# HISTORIC AND DESIGN REVIEW COMMISSION

July 06, 2018

**HDRC CASE NO:** 2018-310  
**COMMON NAME:** Light Building  
**ADDRESS:** 420 BROADWAY  
**LEGAL DESCRIPTION:** NCB 432 (SAN ANTONIO LIGHT), BLOCK 16 LOT 14  
**ZONING:** FBZ T6-1, HS, RIO-2  
**CITY COUNCIL DIST.:** 1  
**LANDMARK:** San Antonio Light Building  
**APPLICANT:** Adam Reed/Ford, Powell & Carson  
**OWNER:** Graystreet 420 Broadway, LLC  
**TYPE OF WORK:** Amendment to a previously approved design  
**APPLICATION RECEIVED:** June 14, 2018  
**60-DAY REVIEW:** August 13, 2018  
**REQUEST:**

The applicant is requesting a Certificate of Appropriateness for approval to amend a previously approved design regarding modifications to the historic structure at 420 Broadway, commonly known as the San Antonio Light Building. The proposed amendments are in regards to the design of the south and rear (east) façades where the applicant has proposed a brick and glass curtain wall.

④ SOUTH ELEVATION ALTERNATE WITH FLUSH GLAZING AND REVEAL SECTIONS- 06-08-18  
SCALE: 1/4"=1'-0"

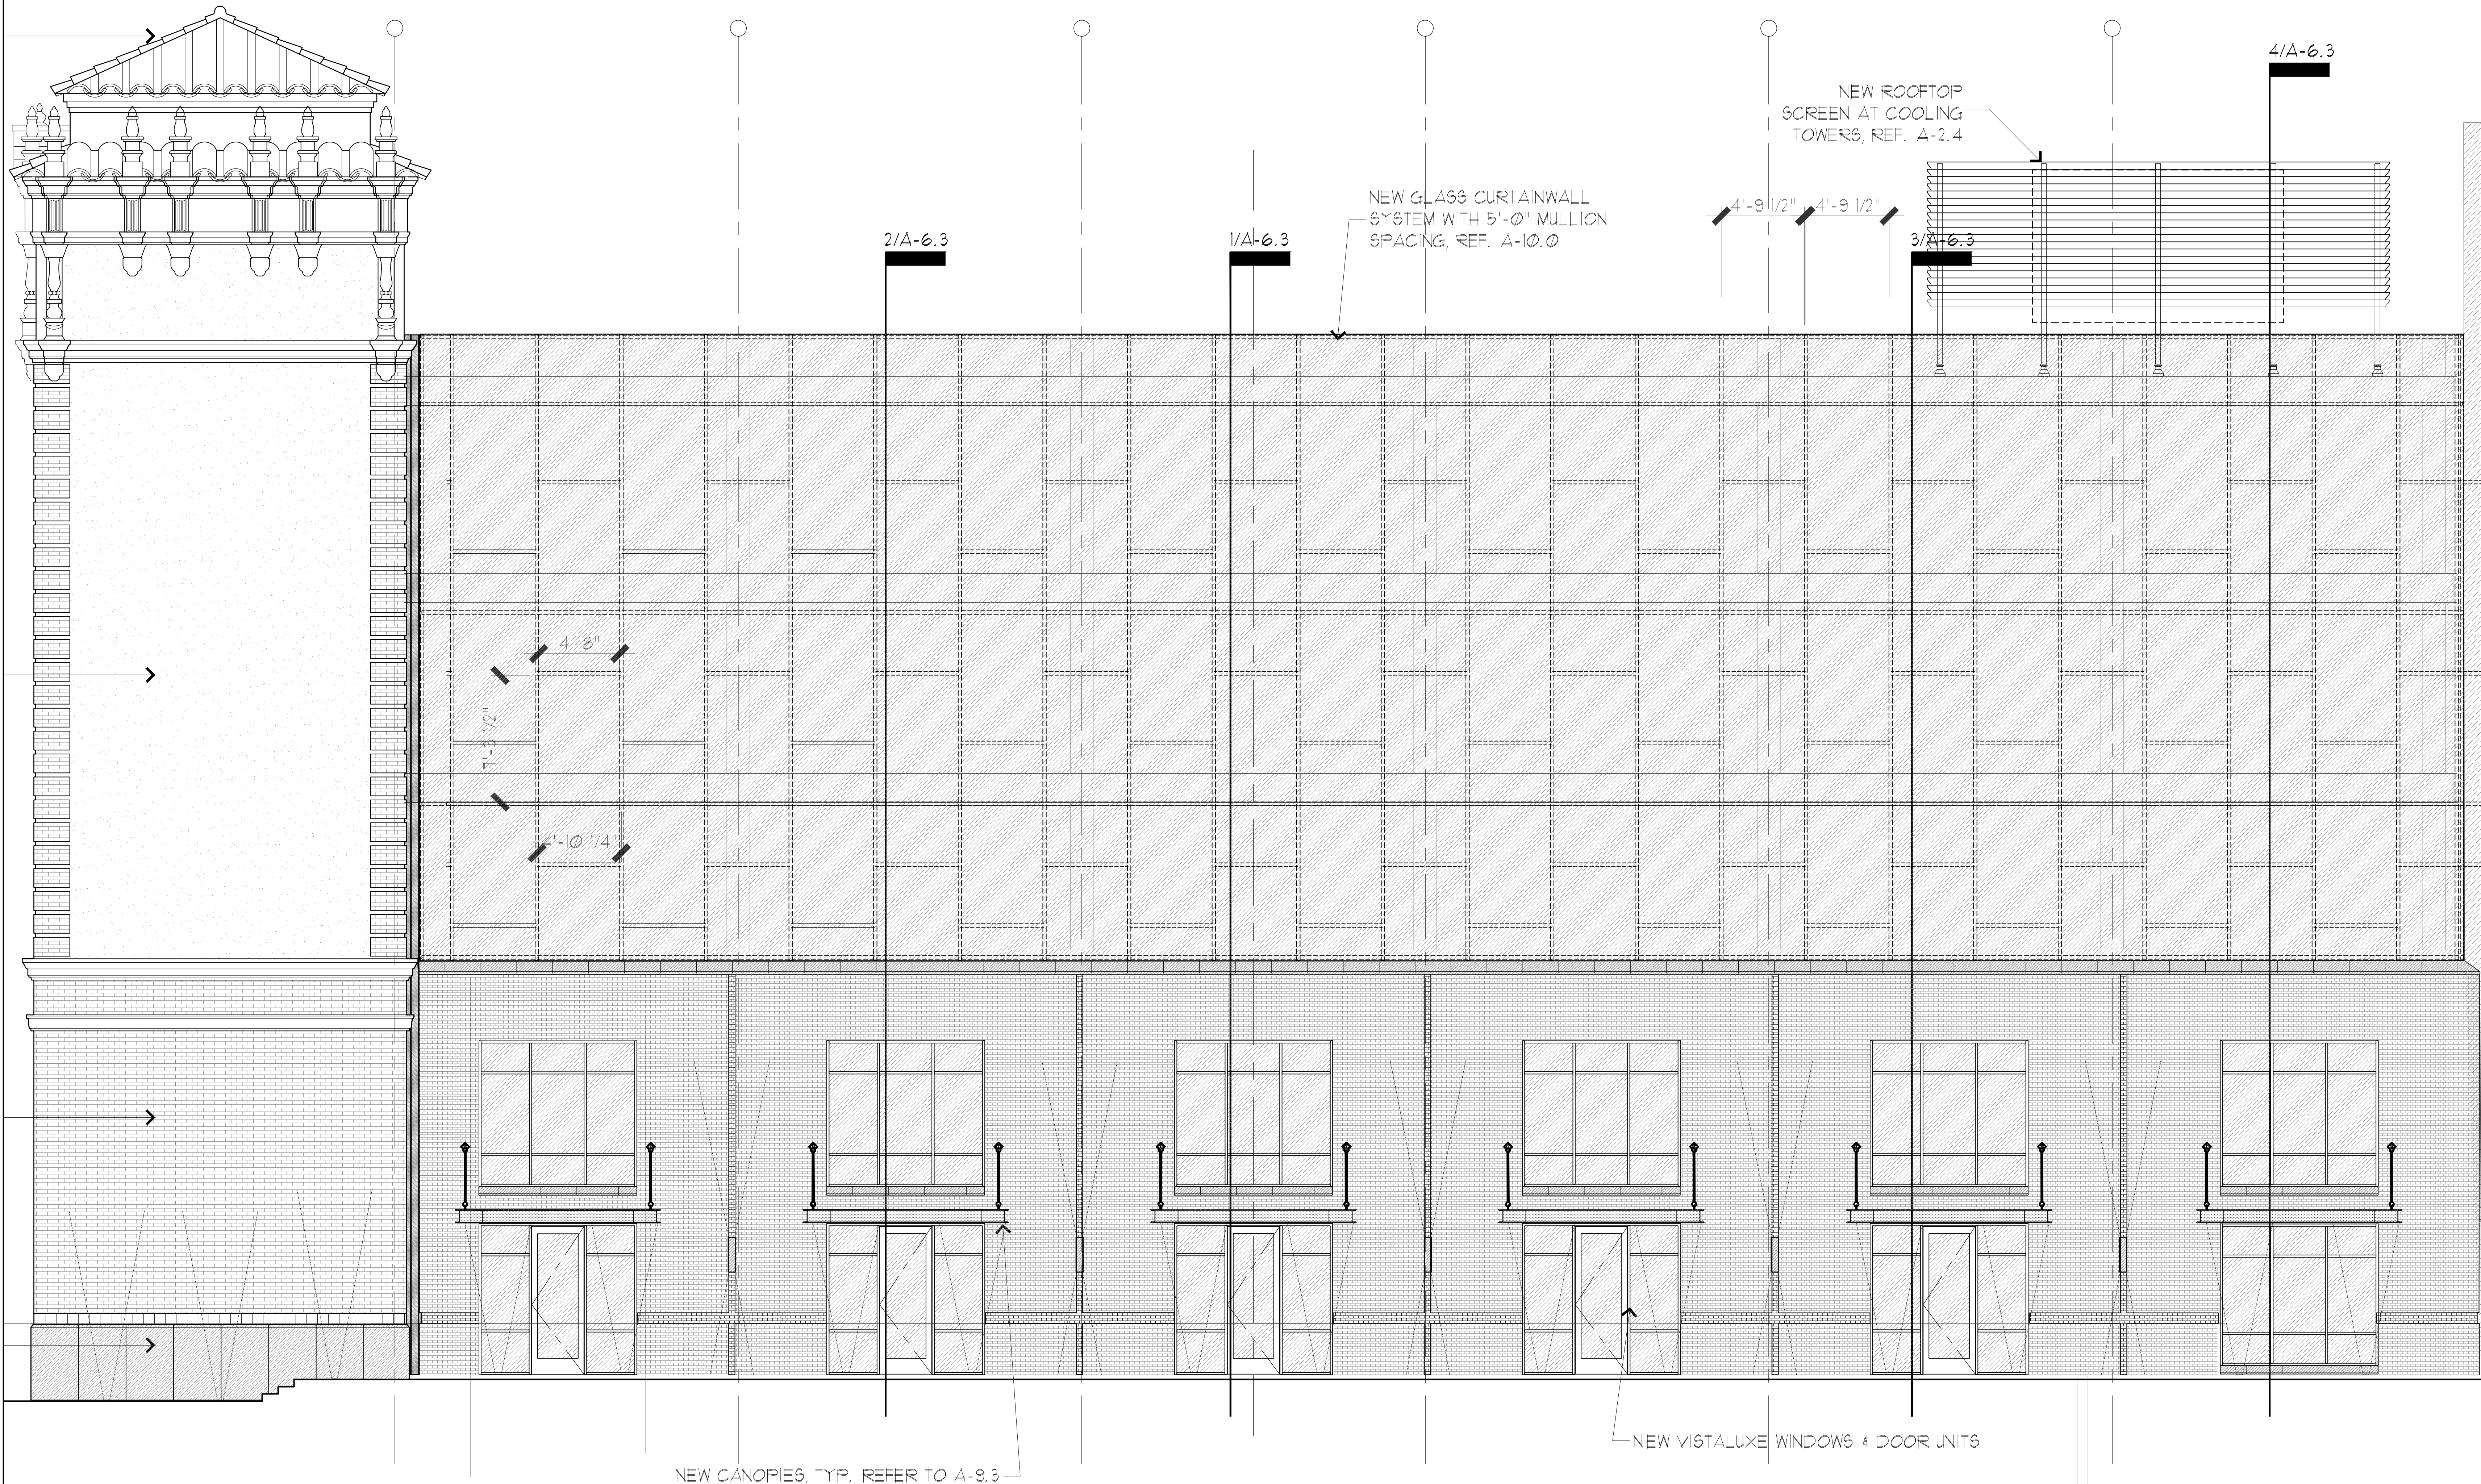
- c. CURTAIN WALL (South & East Façade) – The southern and façade of the Light Building featured a façade that was void of fenestration. The previous approval included a brick curtain wall matching the height of the historic brick on the front (west) façade and glass extending upwards from the brick to the roof line. The applicant has proposed to maintain this previous façade arrangement; however, has proposed the elimination of the D'Hanis Tile tower addition and has proposed modified brick. The previous wall's brick and clay tile were determined to not be structurally sound for property stabilization. Generally, staff finds the proposed modifications to the previously approved design to be appropriate.

- e. ARCHITECTURAL DETAILS – Generally, staff finds the proposed design amendments to be appropriate. The modifications to massing at the southeast corner are consistent with staff's previous findings and recommendation regarding a de-emphasis of massing and design of the proposed corner tower.

NEW BRICK SAMPLES

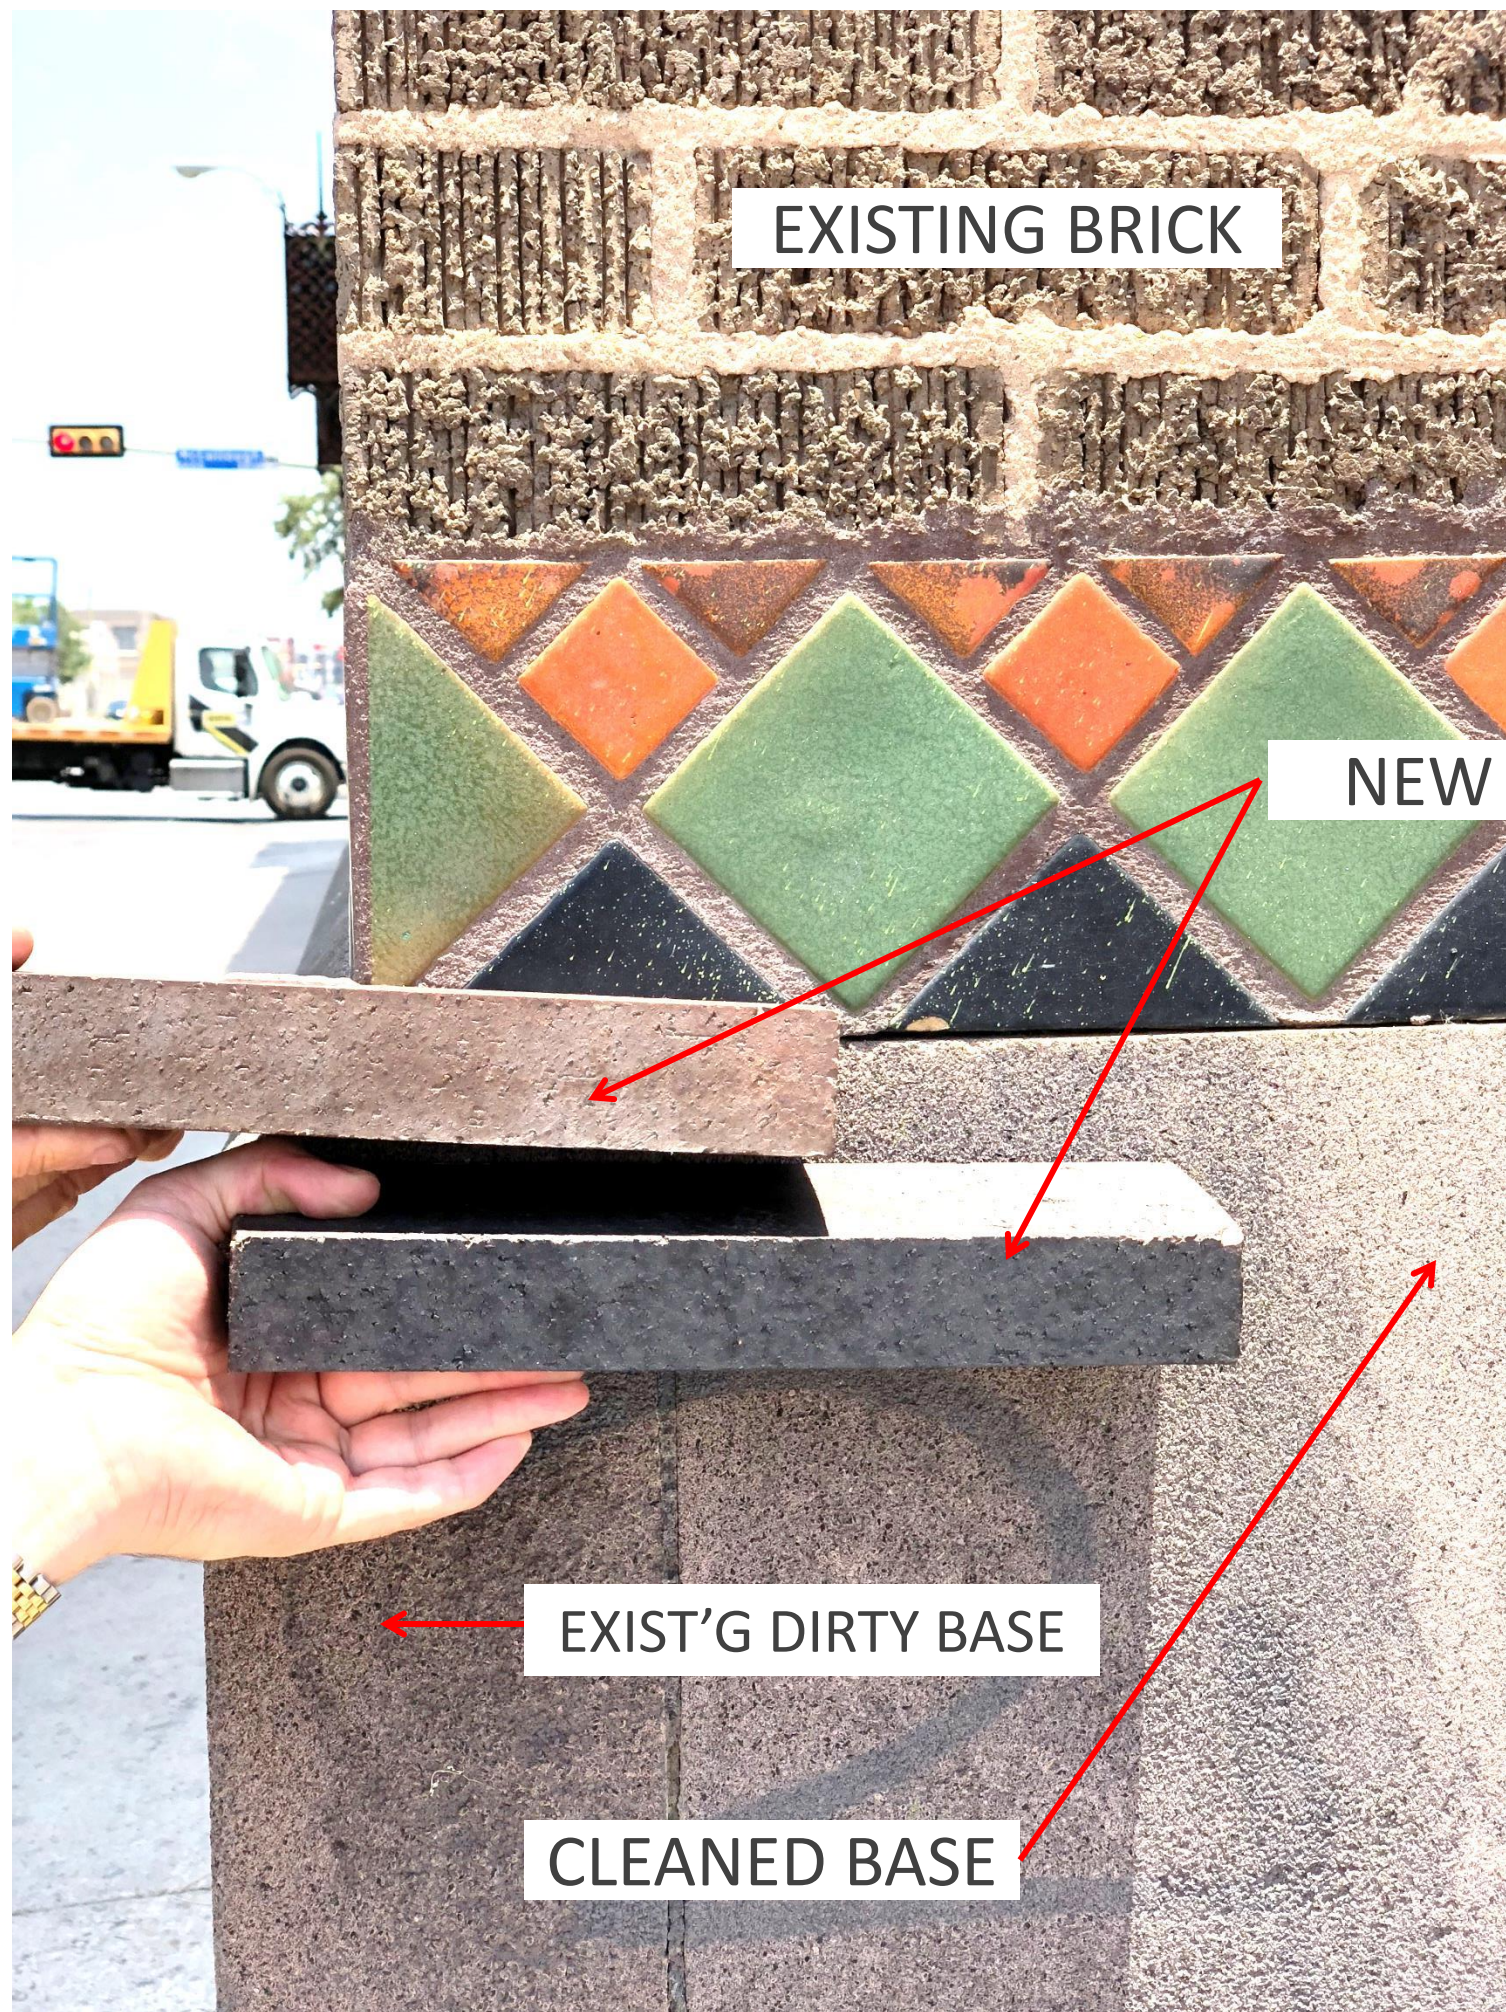
- d. NEW BRICK – The applicant has proposed to reconstruct the brick curtain wall on the southern façade from the ground to the Mezzanine level, consistent with the previous height. The brick will be roman brick featuring a blend of brick in what the applicant notes will accent the darker tones of the concrete base and the mid-tones of the existing masonry of the structure. The proposed brick will not match that found historically on the structure, particularly that of the front façade as to create a separation to differentiate the historic from the new. Staff finds this appropriate.
